TRAILS AT OVERLAND RANCH- FILING 01

SITE PLAN

SHEET TITLE:
TRACKING SHEET

COVER SHEET

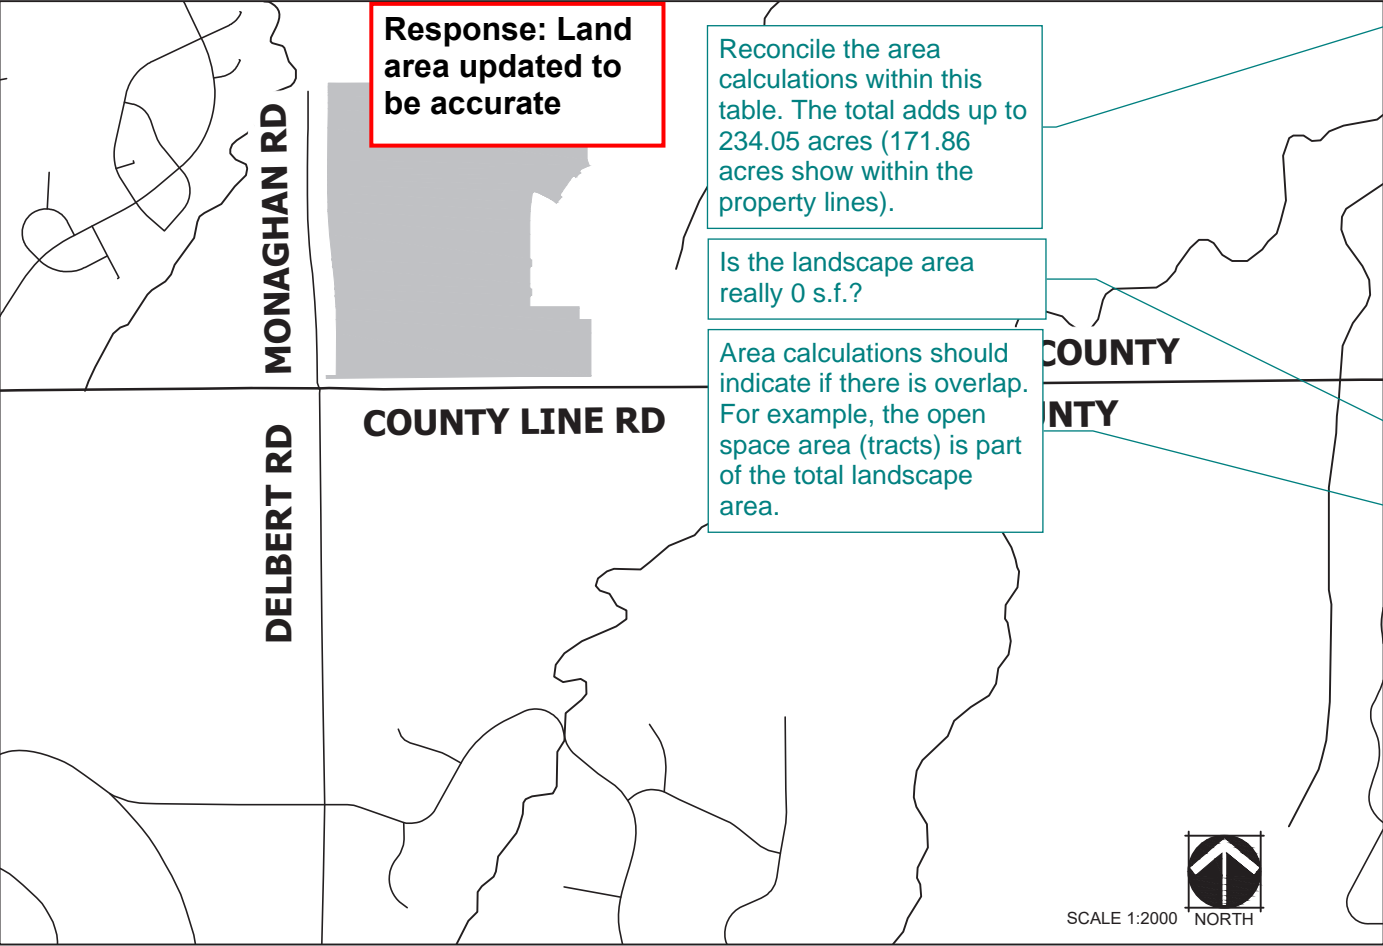
Filing names should not appear in the title. Please make sure the title reads: Trails at Overland Ranch - Site Plan 1

Add V-B construction type and keep non-sprinklered.

Remove "filing".

Add the total parking provided (576 off-street garage spaces)

The site plan will not be approved by Aurora Water until the preliminary drainage letter/report is approved.

Response: Filing removed from and changed to Site Plan 1

Response: V-B added

Response: Filing removed

Response: Parking numbers updated

Response: Noted, thank you

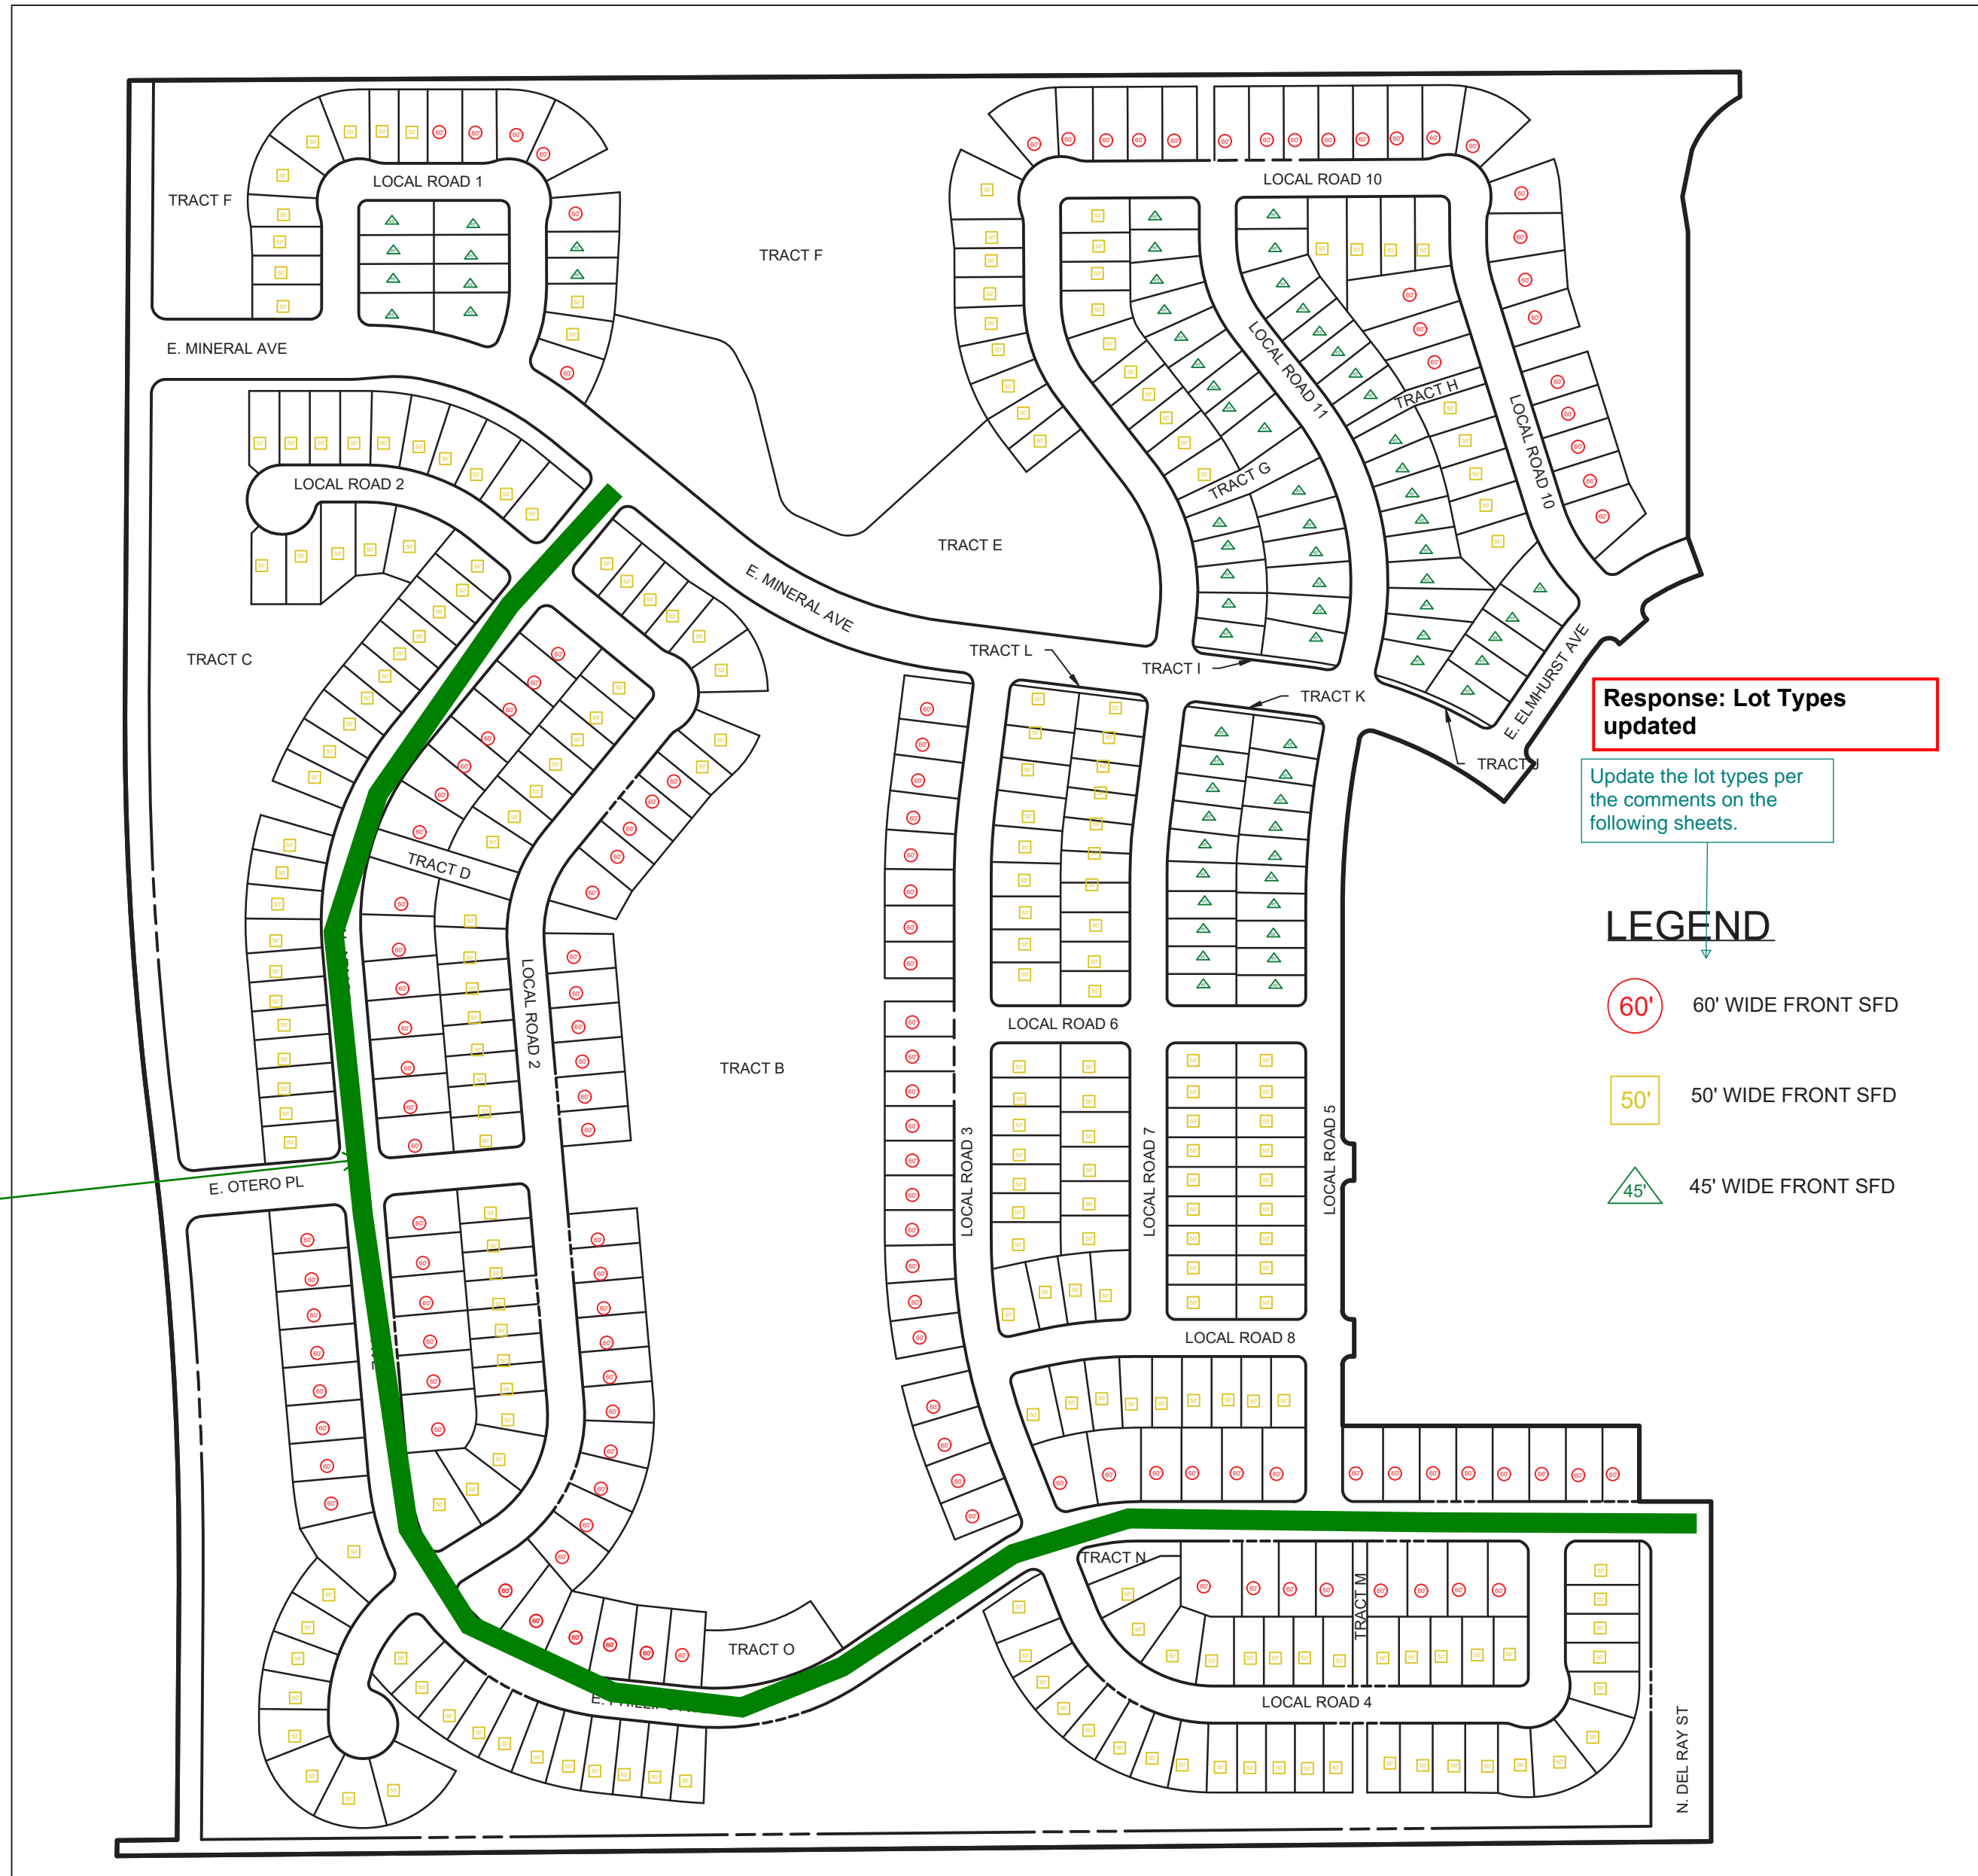
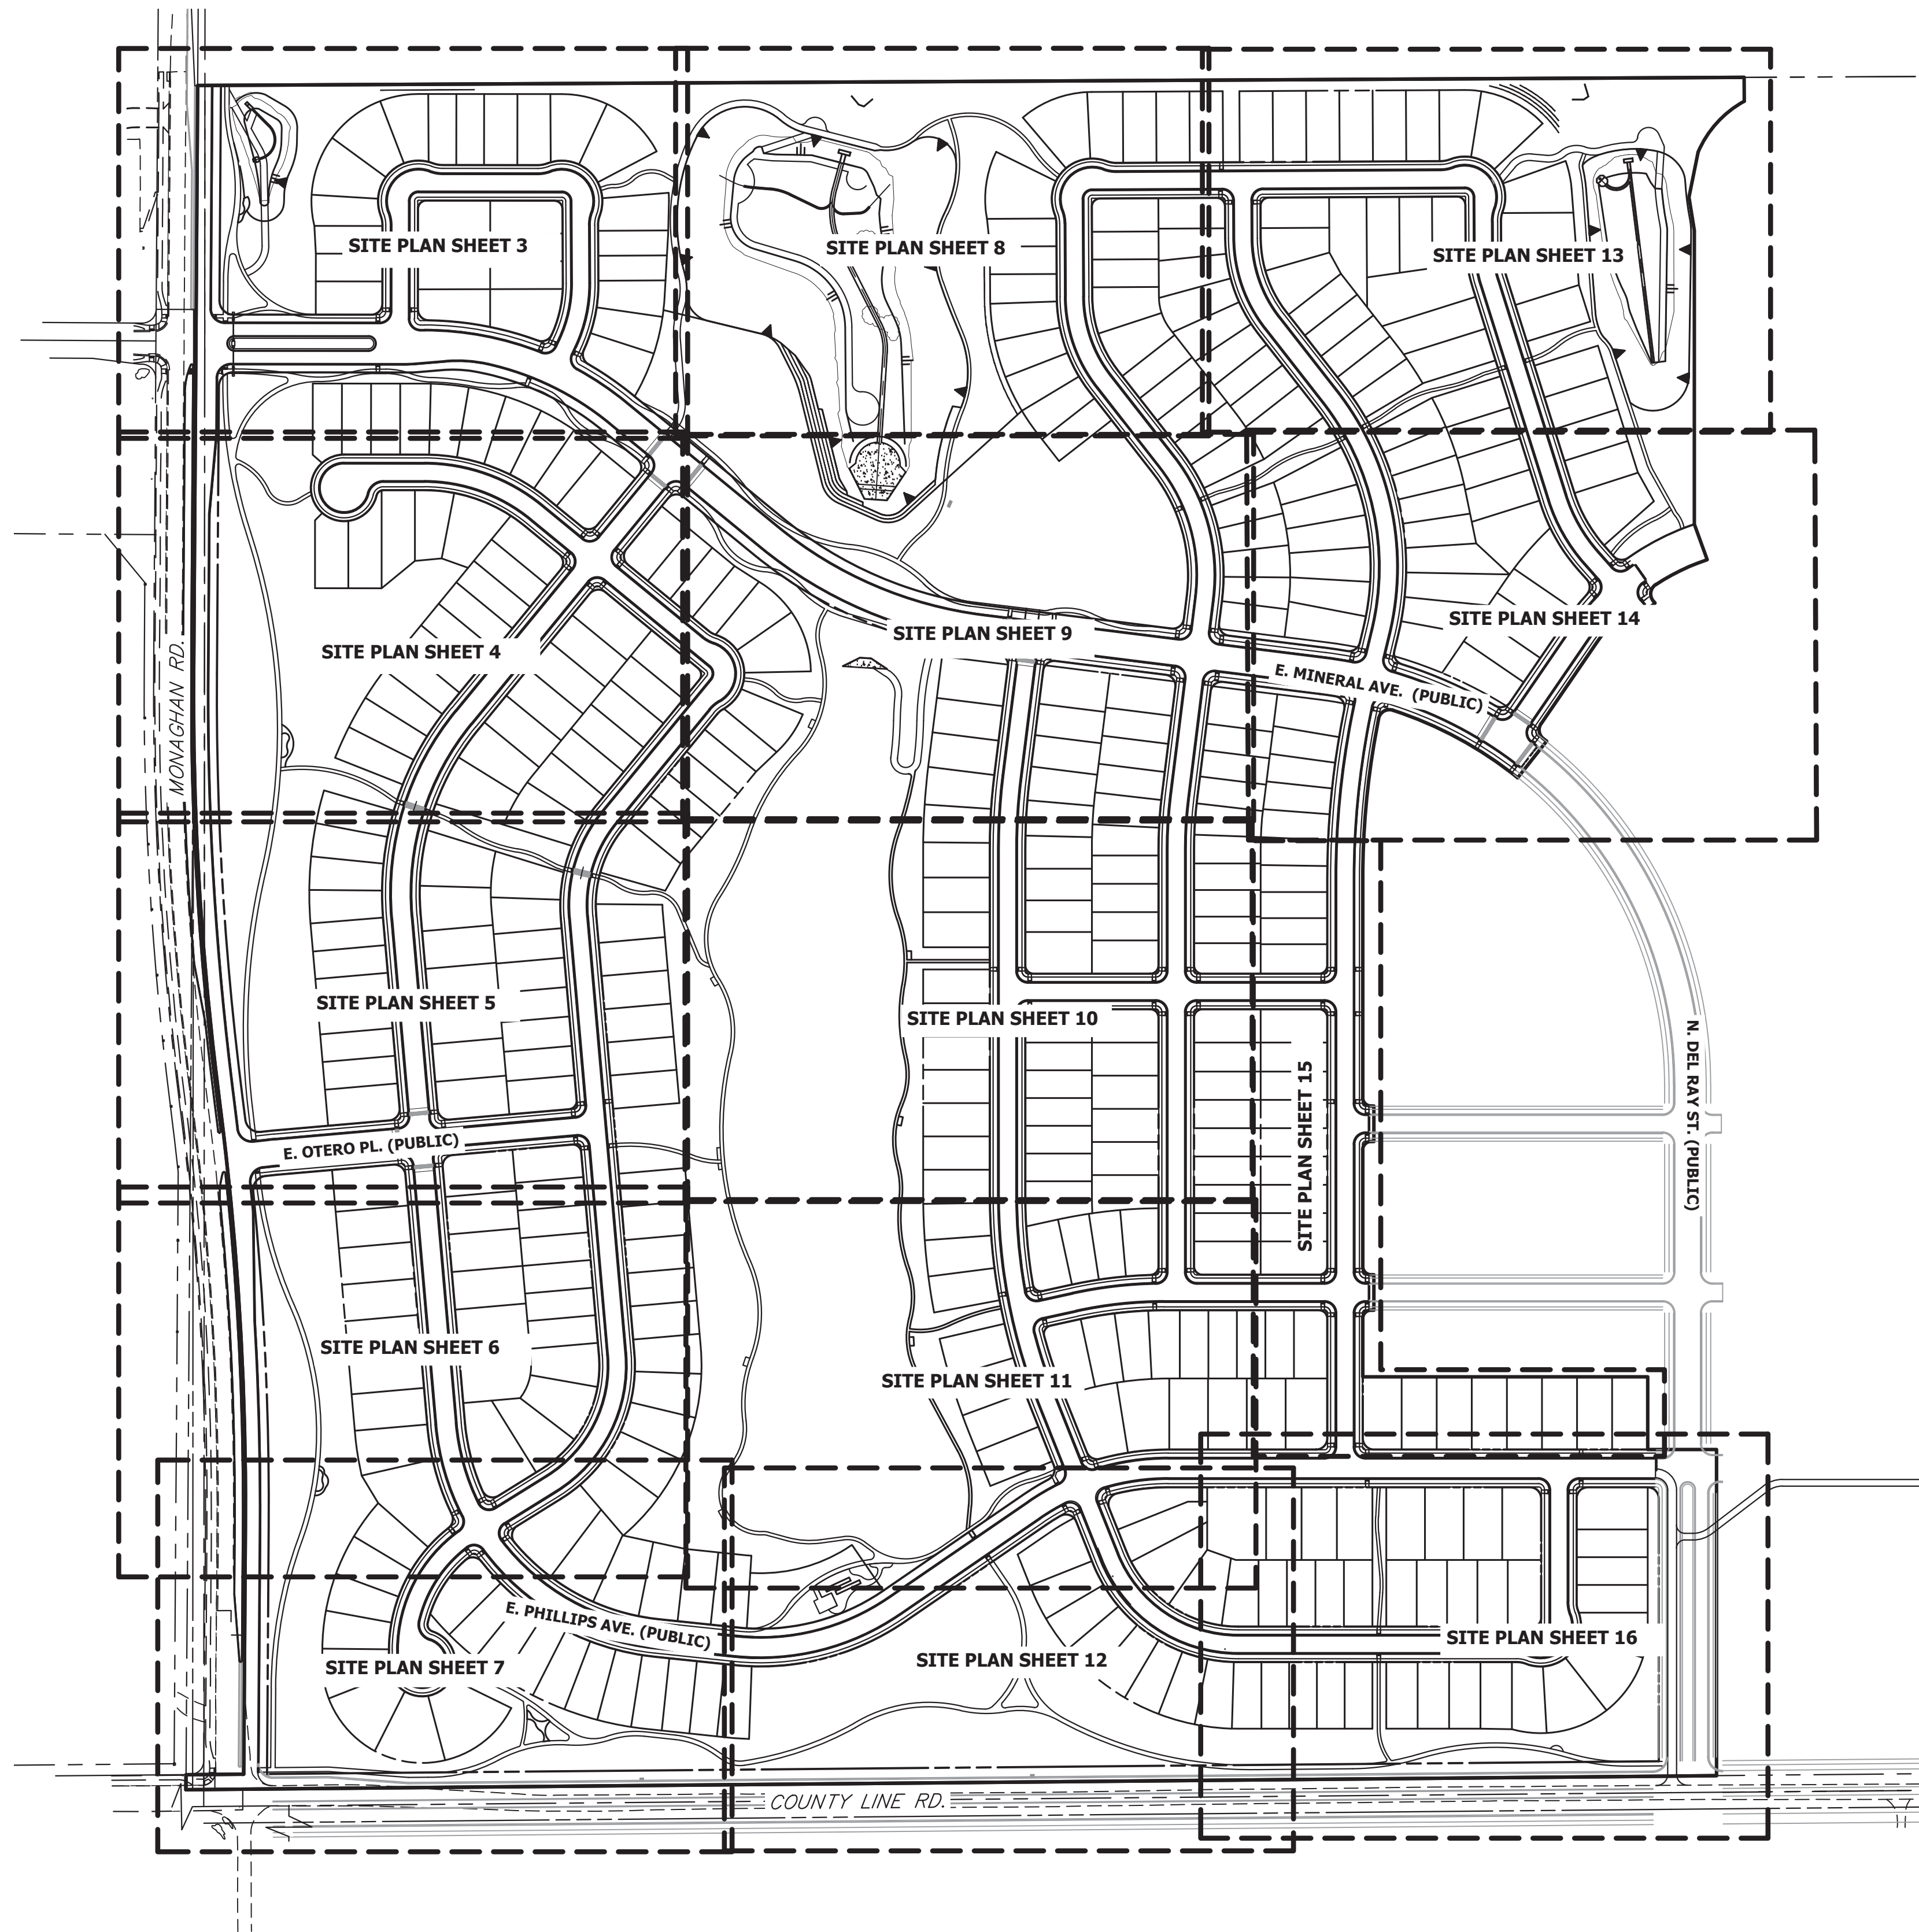
The maximum permitted small lots in R-1 is 25%. Please reference the Master Plan and Section 146-4.2.3.

There is no multifamily within this development. Remove these items from the table.

Please break down the lot tracking table and maximum amount of units table by neighborhood as identified in the master plan.

Correct the small lot count based on the proposed 72 units.

Correct the standard lot count. Make sure it is reflected on all tables throughout.

Change to R-1.

Remove items A-D as they are not applicable to R-1 development.

Update this column to match the master plan form D.

Remove this line item.

As a reminder, per section 4.04.2.02.4 of the Roadway Manual, mitigation measures shall be provided for homes fronting the proposed collector street. Identify the mitigation measures on this site plan.

Response: Removed from the table

Response: Lot tracking table broke down by neighborhood as identified in the master plan

Response: Small lot count updated to 84

Response: Standard lot count updated to 341

Response: Changed to R-1

Response: Items A-D removed

Response: Max units changed to 25%

Response: Changed to R-1

Response: Removed from the table

Response: Min units changed to 75%

Response: table adjusted to what is proposed

Response: Lotting has been updated to include mitigation measures per requirement
